Removing Odometer Pause Wiring Modifications

TSB-54-375-FTL

Figure [1](#) shows the modification diagram for the system to be removed.

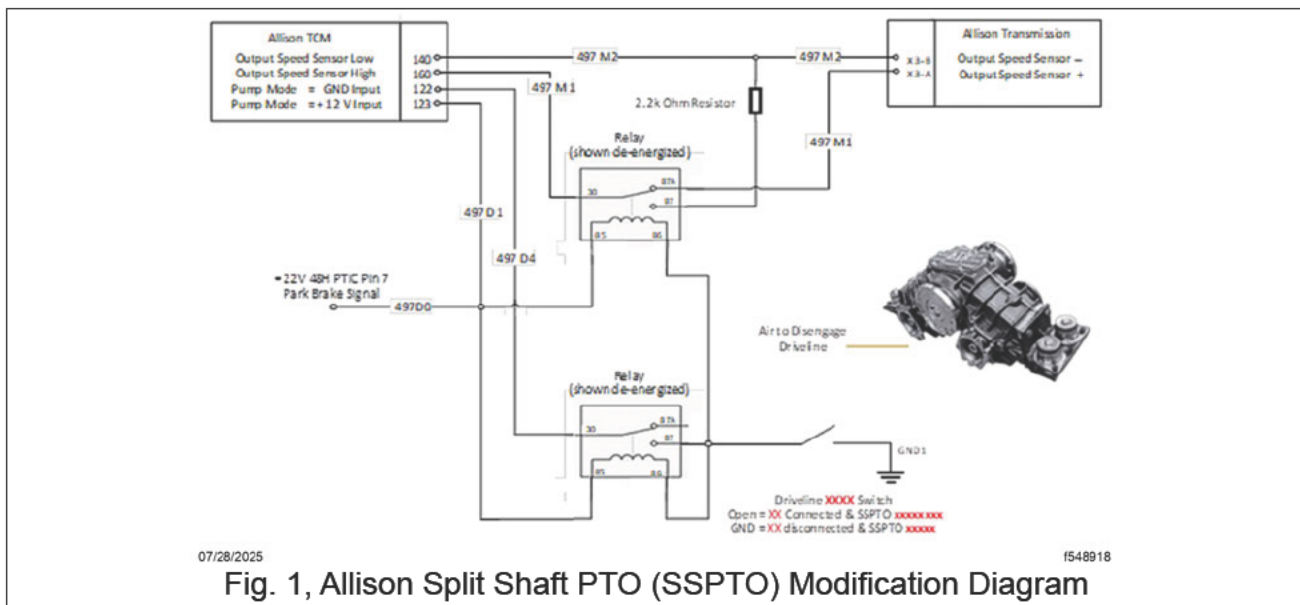
This section describes how to rewire the Allison Output Shaft Speed (OSS) sensor to the Original Equipment Manufacturer (OEM) configuration.

Note: With the relays removed, the control signals, directed to the park brake signal node, and the driveline disconnect switch are to be connected to the Allison Transmission Control Module (TCM) pins 122 and 123. Control signals to TCM 123 and 122 are to be re-established. The two relays no longer sequence signals to the TCM.

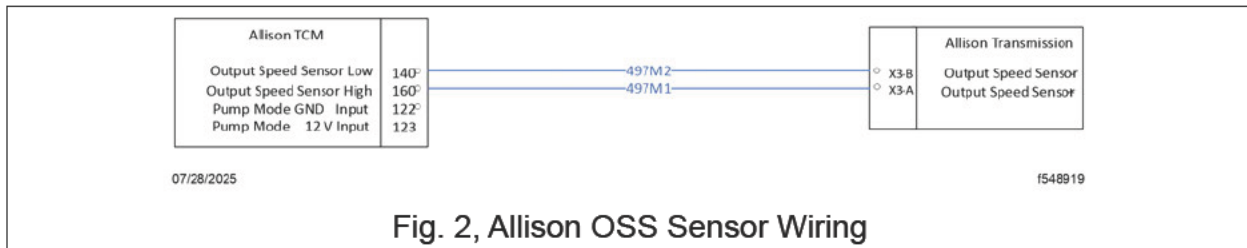
1. ☐ Remove the 2.2K ohm resistor. Leave the circuit 497M2 intact.

2. ☐ Remove both ends of 497M1 from the relay and connect 497M1 again. Leave the TCM pin 160 and the output speed sensor pin X3-4 intact. The final configuration is shown in Fig. 2.
